City of Lakewood  
Board of Building Standards •  
Architectural Board of Review •  
Sign Review Board

MINUTES  
BOARD OF BUILDING STANDARDS/  
ARCHITECTURAL BOARD OF REVIEW/SIGN REVIEW  
REVIEW MEETING  
CITY OF LAKEWOOD  
12650 DETROIT AVENUE  
AUDITORIUM  
AUGUST 14, 2025  
5:30 P.M.  
MEETING RECORDED  
<https://www.lakewoodoh.gov/videos-2/>

**Docket No. 08-71-25 (1586 Lakeland)**

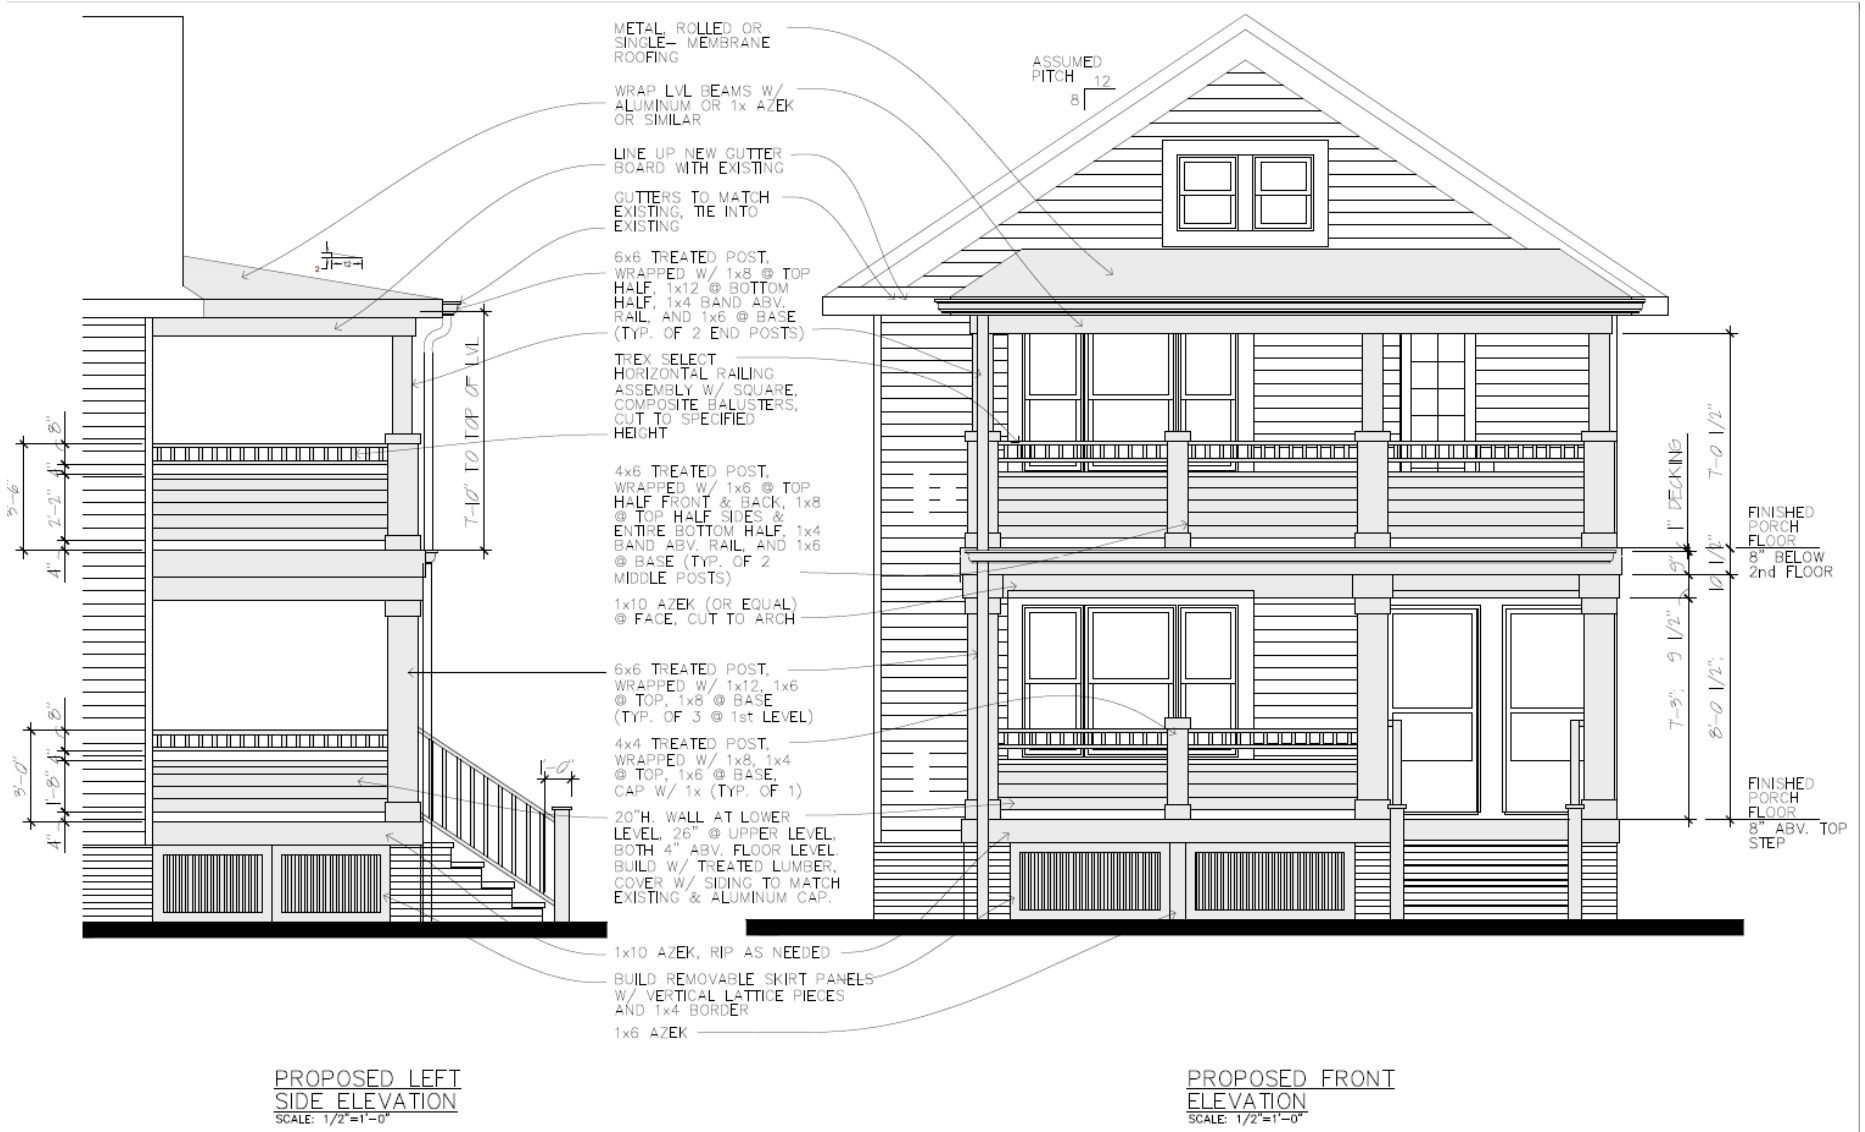
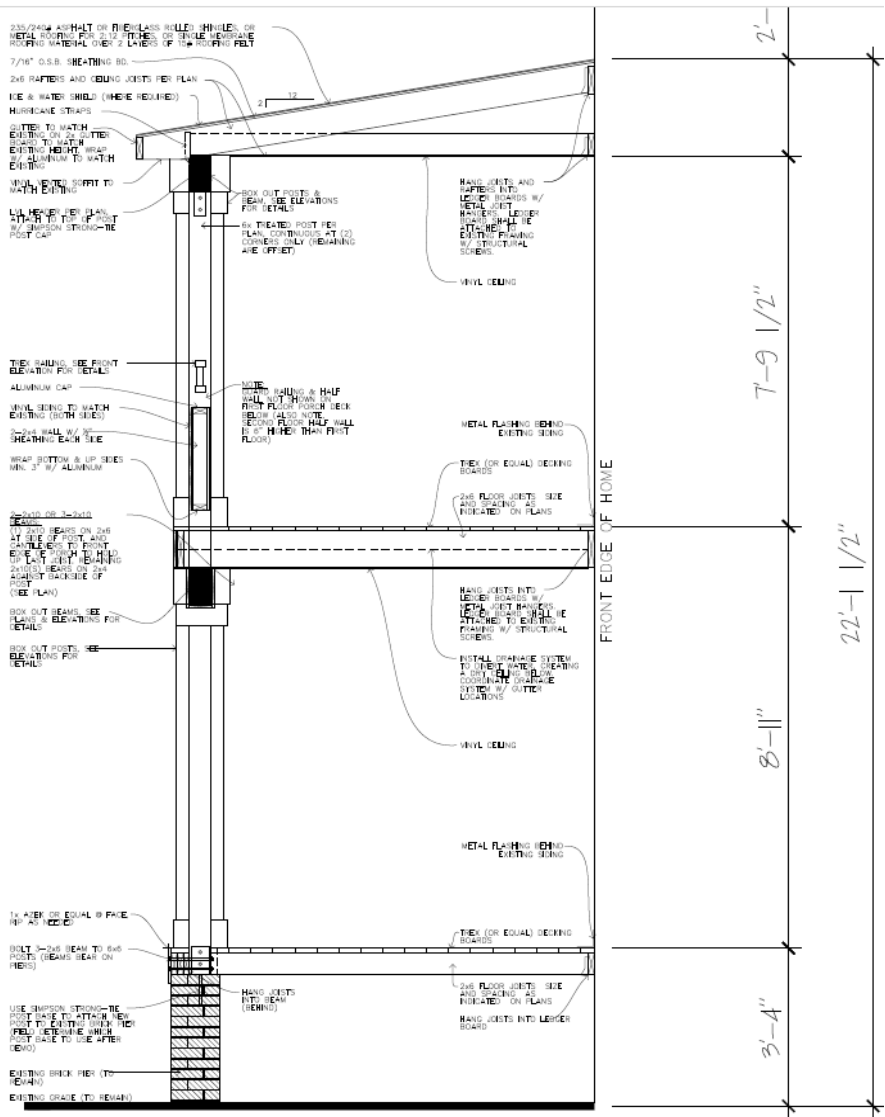
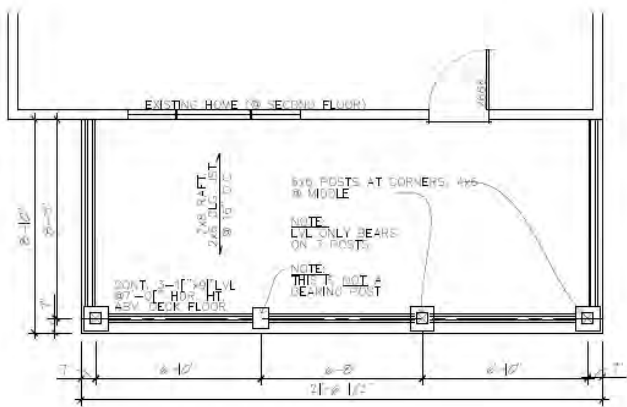
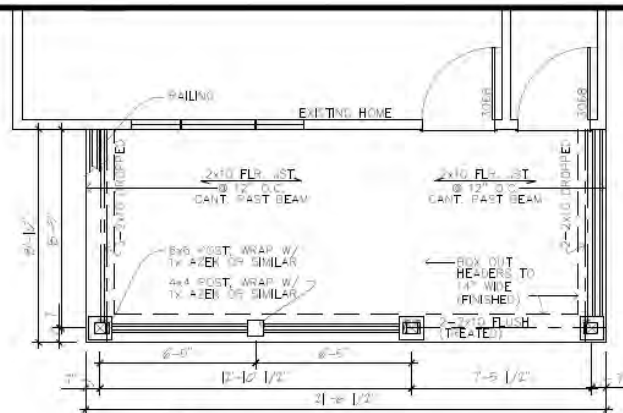
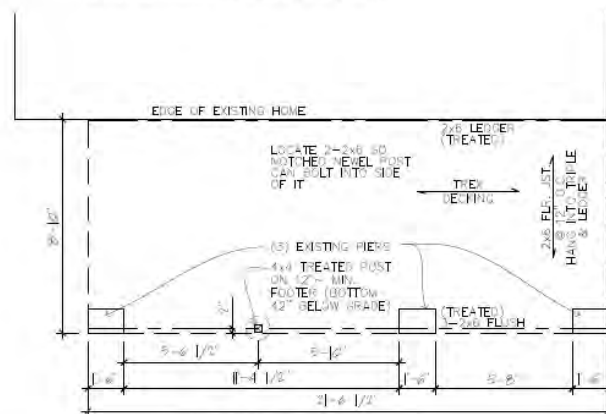
Sam Diaquila AIA, AMSR LLC, applicant was present to explain the request. Discussion was about the shingles, the foundation, the covered railing, the city's railing guidelines, and colors and materials. Staff had no comments. Public comment was closed as no one addressed the item.

A motion was made by Ms. Cohan Plessner, seconded by Mr. Slaughterbeck to **APPROVE** Docket No. 08-71-25 with the following conditions:

**Docket No. 08-72-25 (13815 & 13901 Detroit)**

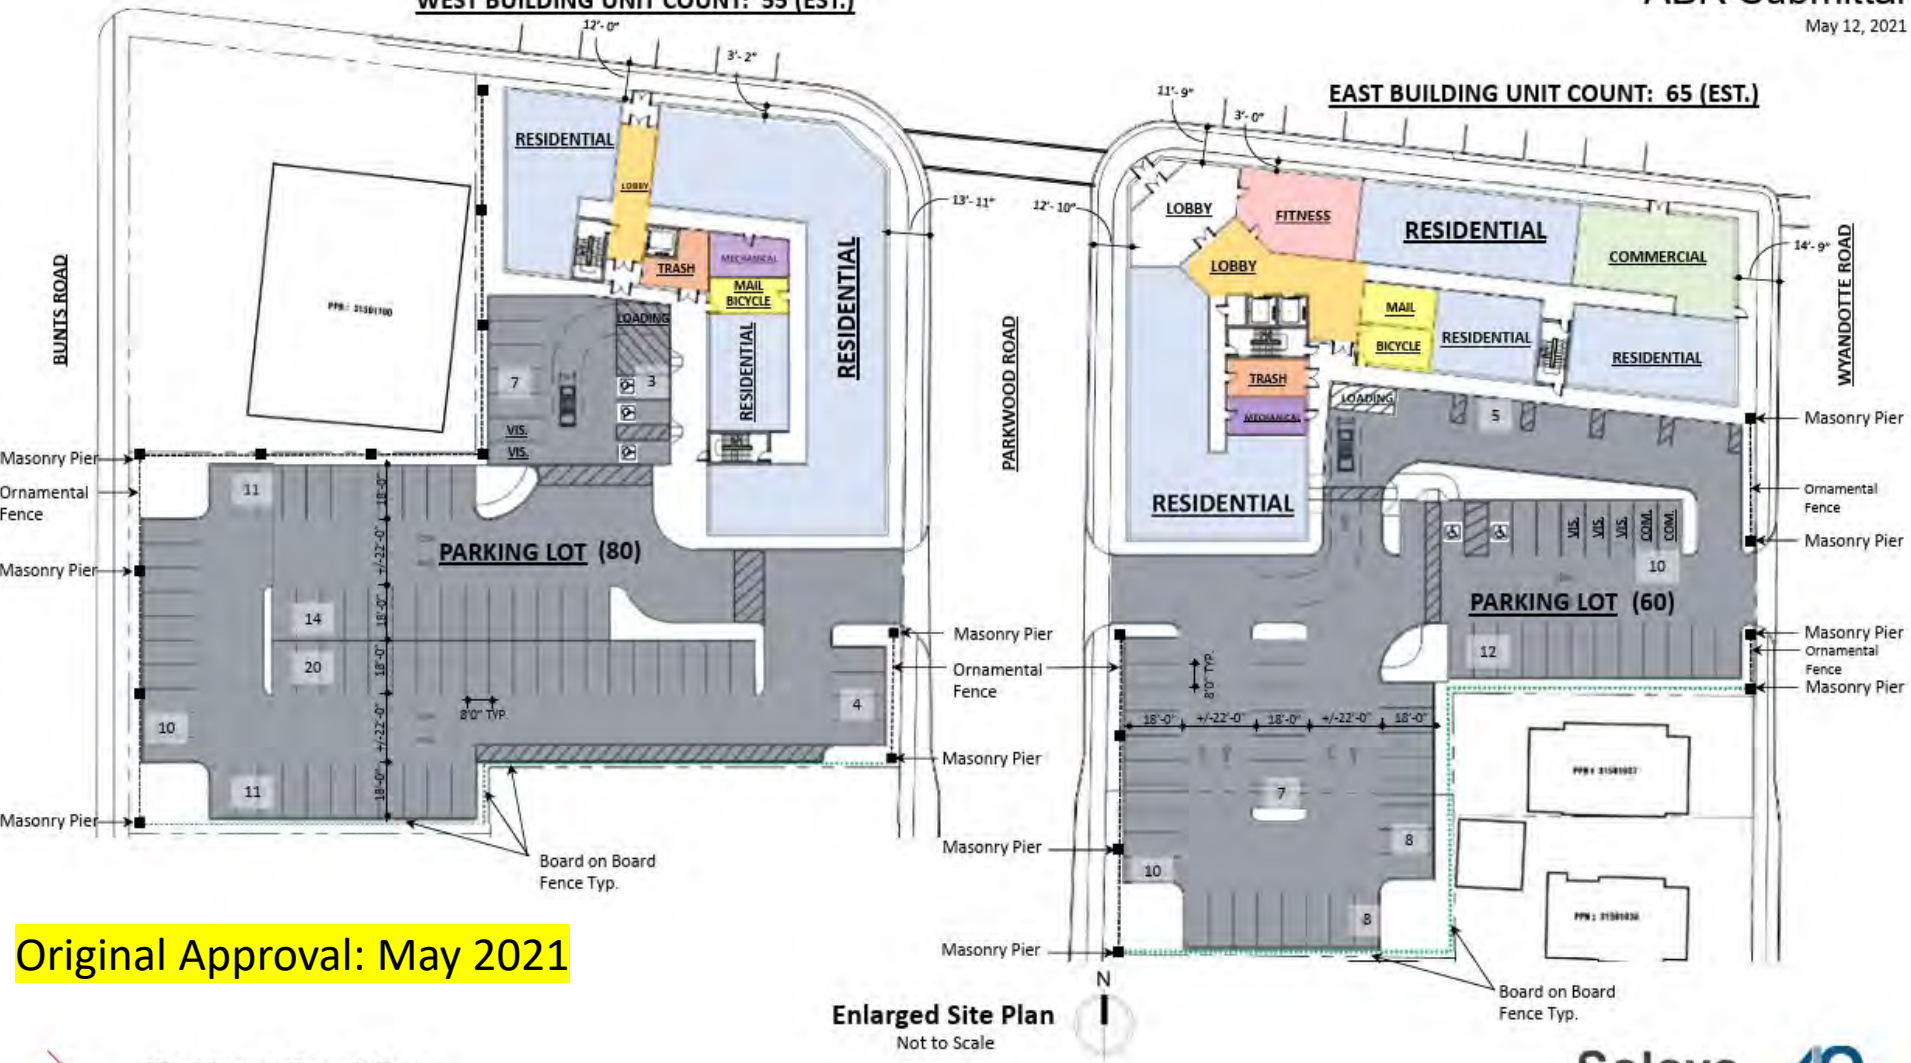
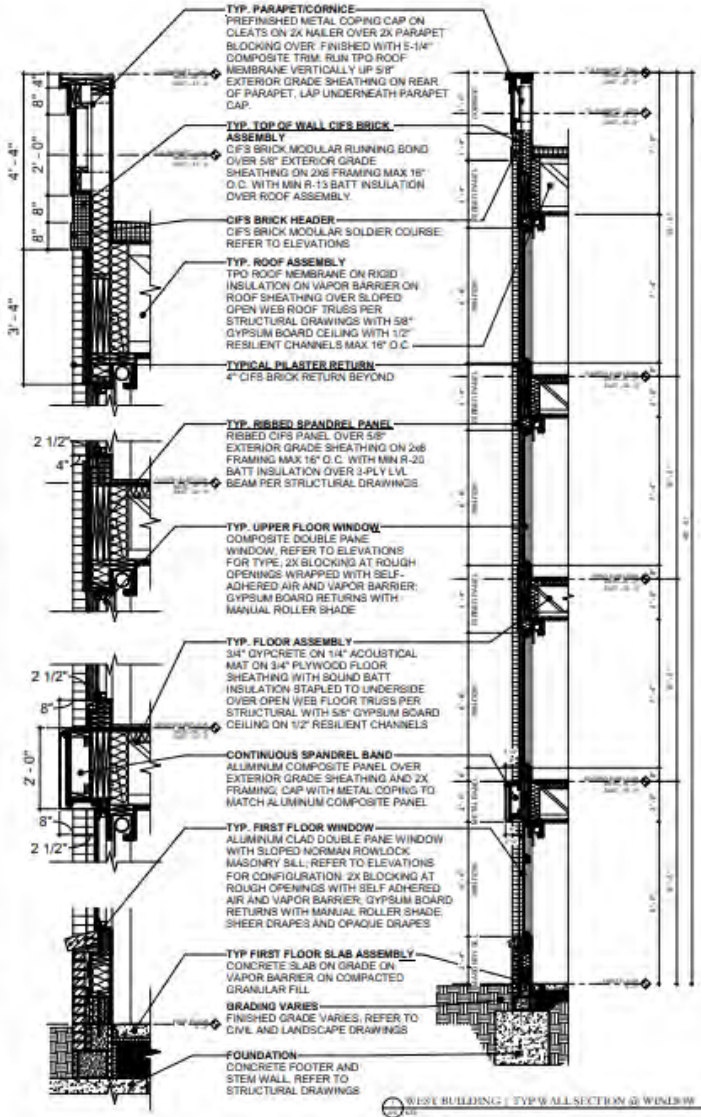
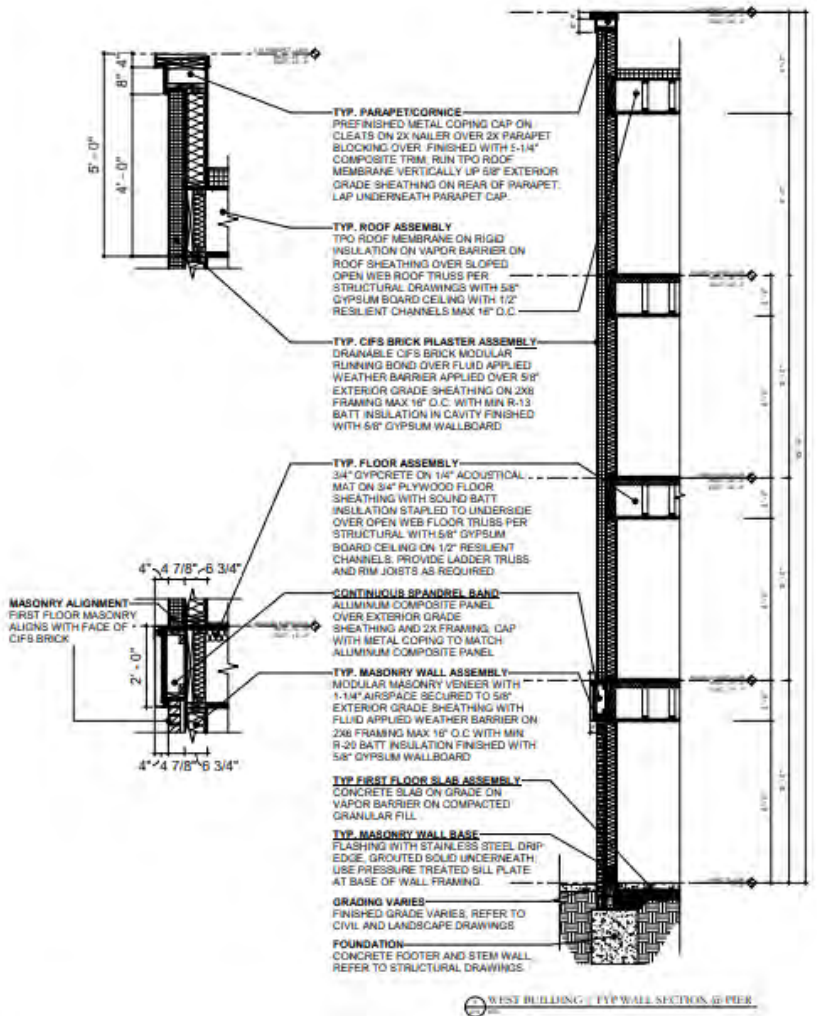
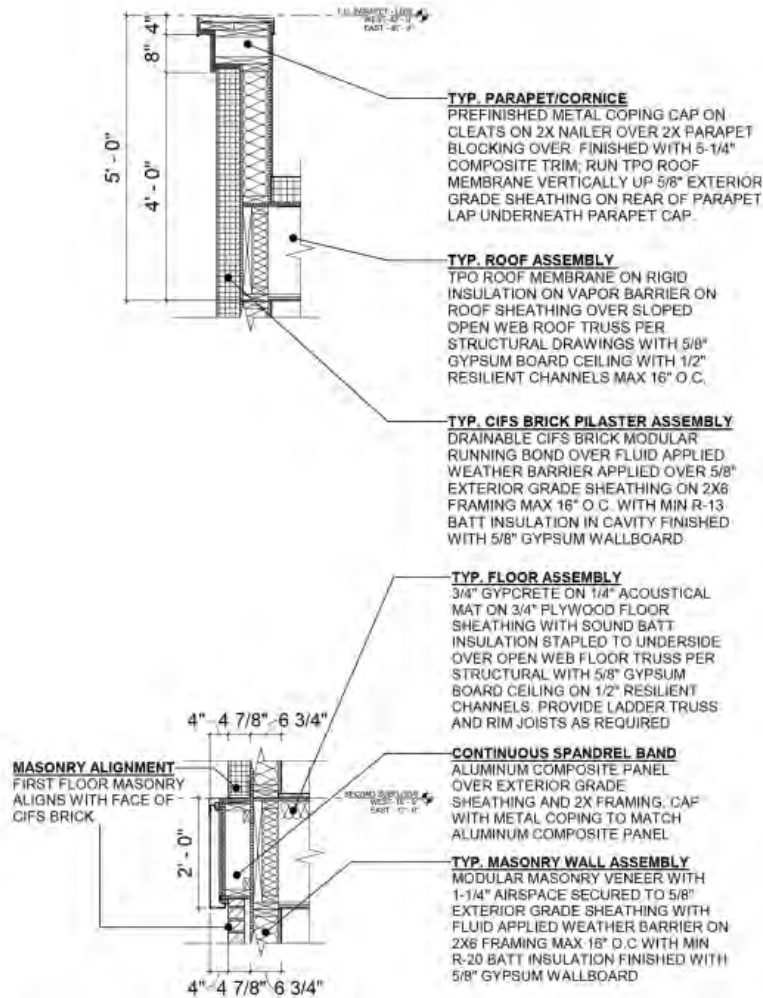
Mackenzie Makepeace, Managing Director, DiGeronimo Development, and Greg Soltis, RDL Architects, applicant, were present to explain the request. Discussion ensued about EIFS materials, staff stated that no other EIFS materials were being used for the city's other current development(s), EIFS today versus 20 to 30 years ago. Discussion continued about the first floor heights of the two buildings, to provide street trees, asked about the different Juniper heights, landscaping, planters needed to be studied, ground-floor residential units, parking, more prominence to the entrance of the west building, articulate the first-floor band, provide pet-relief areas, to add bike racks along Detroit Avenue. Conversation moved to the elevations. EIFS was discussed at length. Colors and materials were discussed, along with the width of the detailing at the top of the buildings, and cornices. Staff stated the width of the sidewalk was less than the Barry Buick site that was referenced. Public comment was taken. A comment received prior to the meeting was read into public record. Ms. Makepeace stated that if EIFS was not allowed, the project could not proceed. Also stated was that the first floor residential units did not comply with the city's commercial design guidelines.

| <input checked="" type="checkbox"/> | Define corners and how elevations change when approaching residential areas         | Corners along Detroit are well defined   |
| <input checked="" type="checkbox"/> | Study adjacent buildings for horizontal context lines                               | Refer to elevations and Commercial District Design Principles sheet  |
| <input checked="" type="checkbox"/> | Better define articulations   | Articulations are more defined and provide depth to the elevations   |
| <input checked="" type="checkbox"/> | Consider additional landscaping buffer at fences                                    | Refer to landscape plan and planting schedule  |
| <input checked="" type="checkbox"/> | Cable railing may not be effective in creating differentiation                      | Refer to revised product brochure  |
| <input checked="" type="checkbox"/> | Consider additional details at parapet coping                                       | Current design show parapet detailing  |

A motion was made by Ms. Cohan Plessner, seconded by Mr. Stevenson to DEFER Docket No. 08-72-25. All the members voted yea; the motion passed.
